SUBMITTER No.	1840	ISSUE REFERENCE:	9109
SUBMITTER TYPE	Council	TOR CATEGORY	Social / Waste / Land
NAME	Barcaldine Regional Council	RELEVANT EIS SECTION	1.1.4

SUBMITTER No.	1840	ISSUE REFERENCE:	12021
SUBMITTER TYPE	Council	TOR CATEGORY	Air Quality / Land
NAME	Barcaldine Regional Council	RELEVANT EIS SECTION	Air Quality, Vol 2 Chapter 10

SUBMITTER No.	419	ISSUE REFERENCE:	4001
SUBMITTER TYPE	Government	TOR CATEGORY	Land (Land Contamination)
NAME	DERM	RELEVANT EIS SECTION	Volume 2, Mine – Section 3.4.6.2 (p131)

Figure 1. Mine Location Map

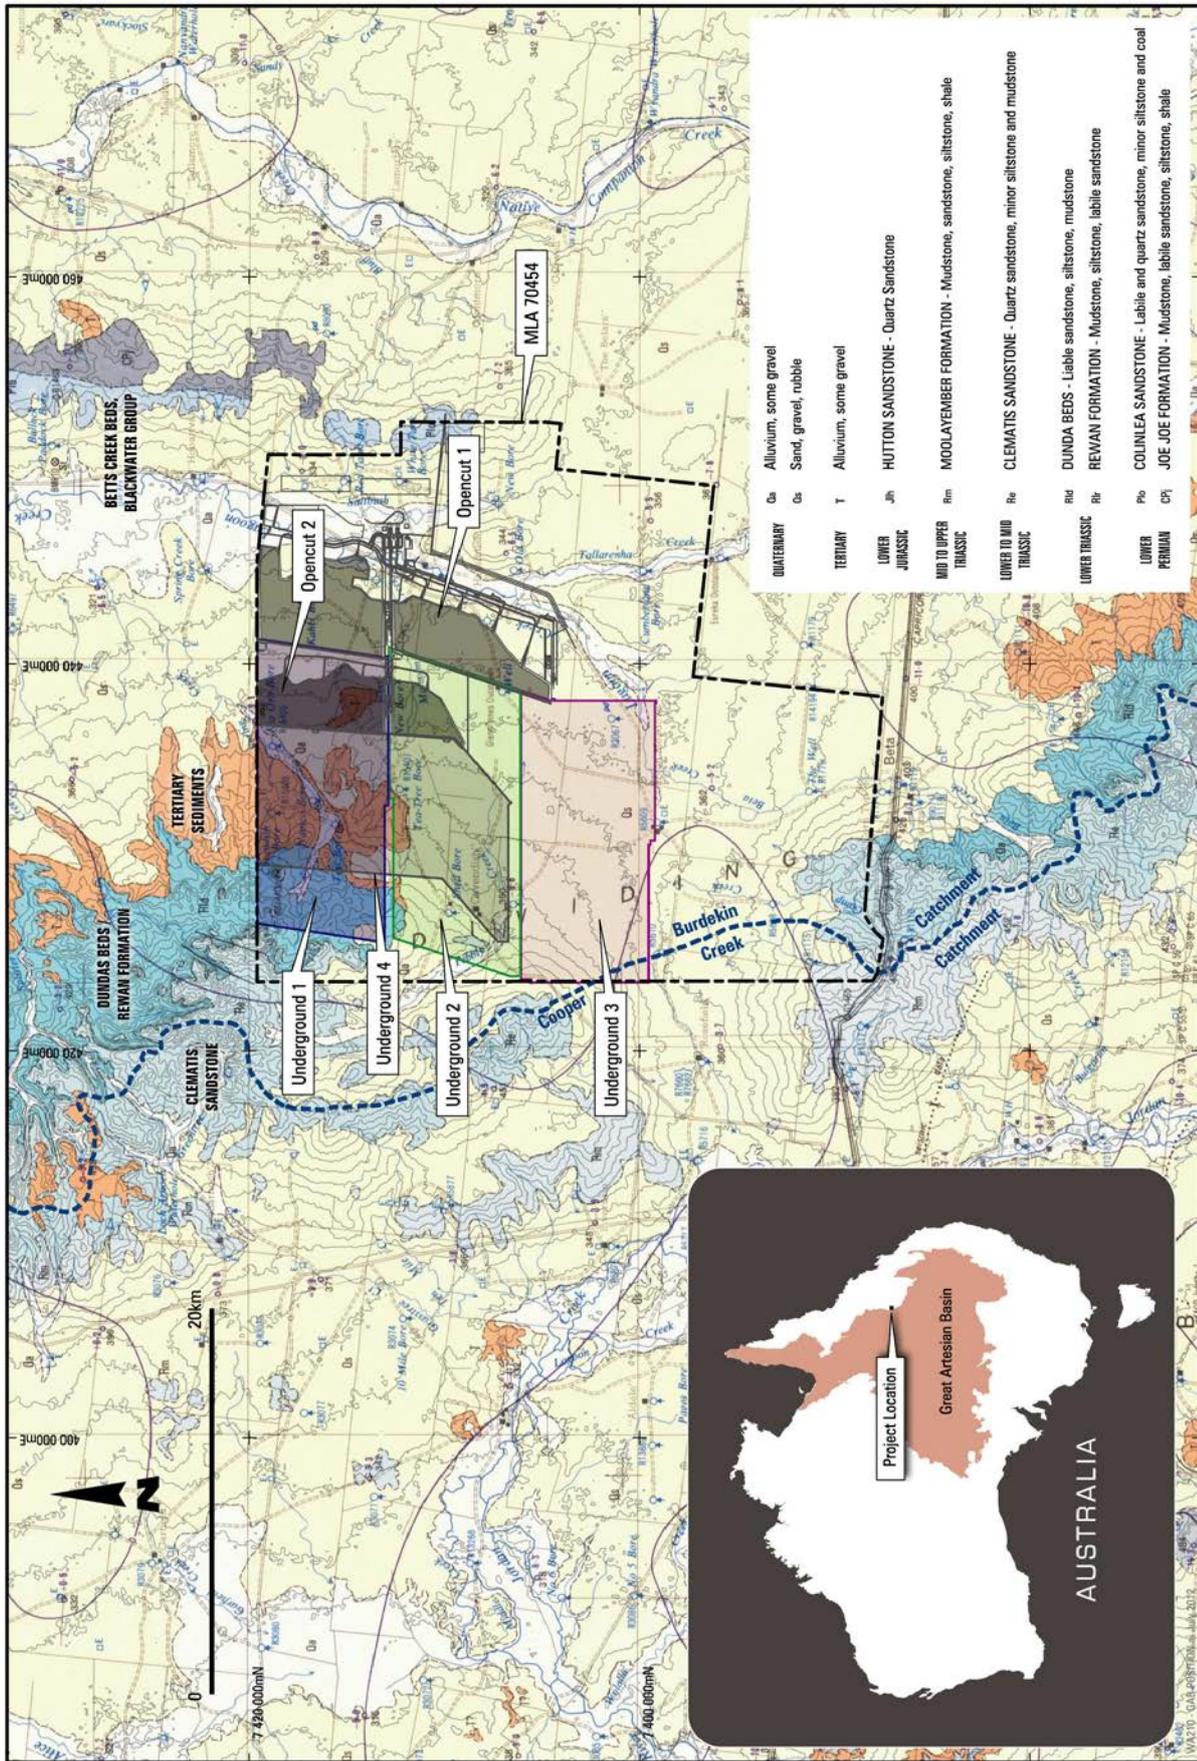
All cross sections that are provided throughout the EIS provide little indication of where the mine starts and stops in relation to the cross sections and no plans are supplied with the cross sections again to demonstrate where the sections run.

The EIS should provide a west to east cross section(s) that clearly identifies the extent of the proposed mining area (the mine footprint) along with the geological formations (including the Rewan) to the west and east of the mine site.

Waratah Coal have now completed more detailed investigations into the geographical location of the mine area in relation to the mapped or recorded underlying geological lithologies and specifically in reference to the Great Artesian Basin. See Figure 1.

Mine Location Map, Showing Mine foot print, (both open-pit and underground), the Great Dividing Range as a barrier between Coopers Creek and Burdekin Catchments. Mapped Geology is from the Jericho 1:250K government series SF 55 - 14.

Figure 15. Illustrated schematic of the proposed development

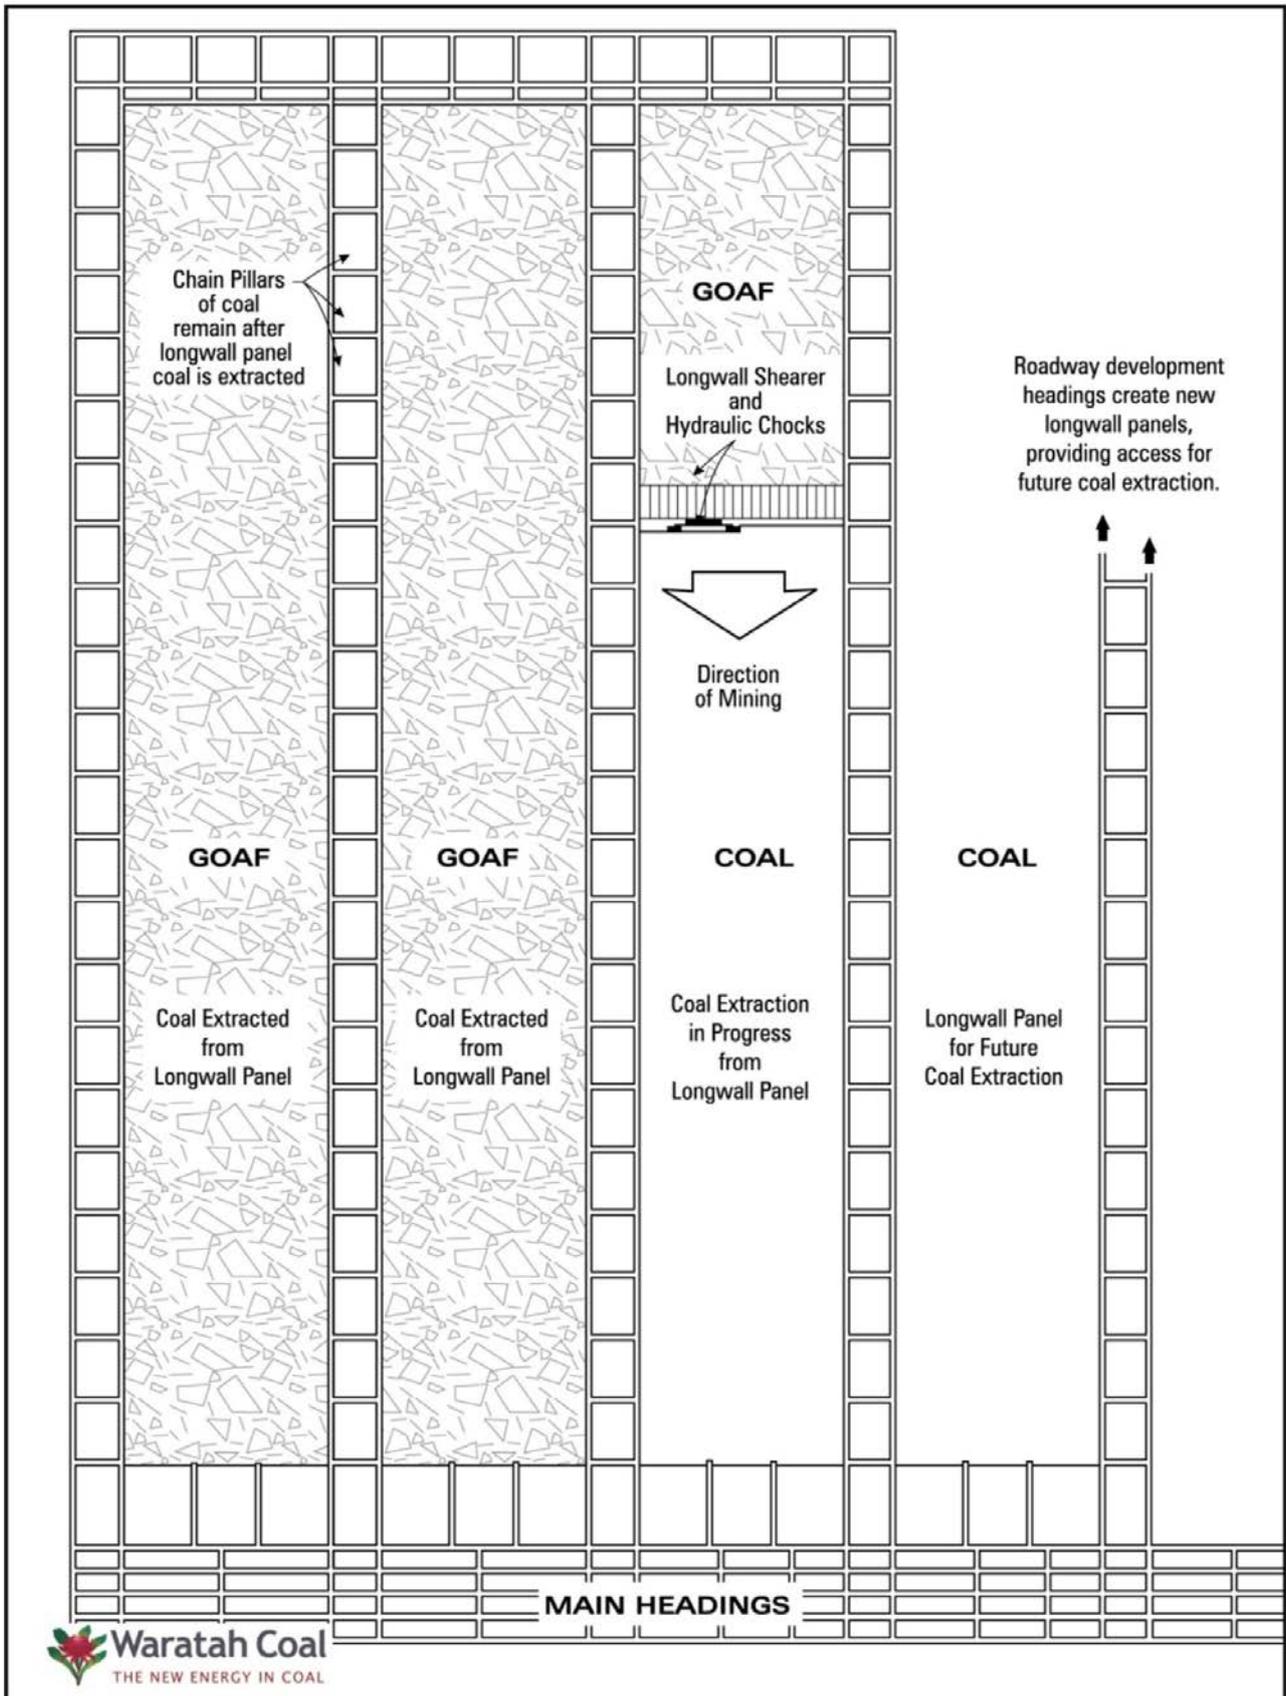
A long term plan for the final land form and rehabilitation is required prior to impacts occurring. Further works and understanding is required to enable reinstatement of grazing industry following LOM as it has been noted that major subsidence is predicted and final voids will be of up to 120m in depth.

The proposed longwall blocks have a mining width of 470m, rib-to-rib and a chain pillar width of 20m to 50m (solid), pillar width increase with depth of cover. The lengths of the longwall blocks will be up to 7,000m. Between each longwall extraction block, a coal chain pillar will be left with a total width of 20m to 50m rib-to-rib and a length between cut-through of 95m rib-to-rib. An illustrated schematic of the proposed development is shown in Figure 15.

Figure 16. Prediction curve for maximum incremental subsidence with the estimated linear relationship, MSEC Trend, adopted for Galilee Basin

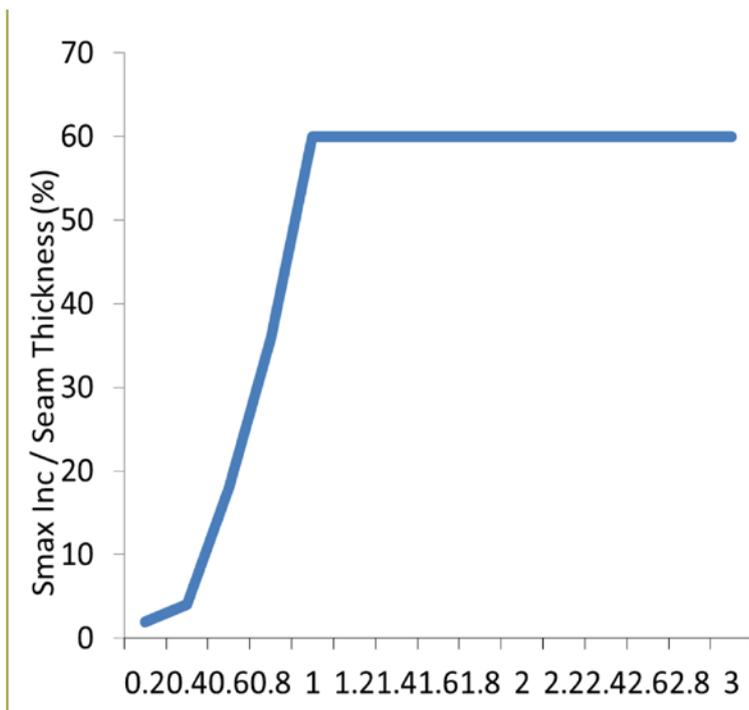
- What is the current level of understanding of the impacts on the expected subsidence?
- Predicted 3.6m maximum and 1.3 to 1.61. Where will these drainage pattern impacts occur?
- The post mining industry reinstatement for industry such as cattle requires further planning.
- Please provide information on expected costs to manage the subsidence drainage issues.
- Please provide information on impacts to cropping.

The subsidence profiles used for the 3D extrapolation are based on subsidence parameters of angle of draw, maximum subsidence and pillar subsidence. Subsidence ranges from supercritical to subcritical below a depth of 481m. A caving angle of 26.5° has been used in this report.

Total subsidence comprises sag subsidence between pillars and the abutment subsidence above the pillars. The maximum sag subsidence is determined using the maximum subsidence/seam thickness and panel width to depth ratio profile as outlined in Figure 16, and is based on the prediction curves in MSEC (2007)⁵. The maximum sag subsidence for supercritical subsidence has a ratio of 0.6 times the seam thickness. For subcritical subsidence, the maximum sag subsidence is reduced as per the trend in Figure 16. Tables 2 and 3 give the summary of the calculations.
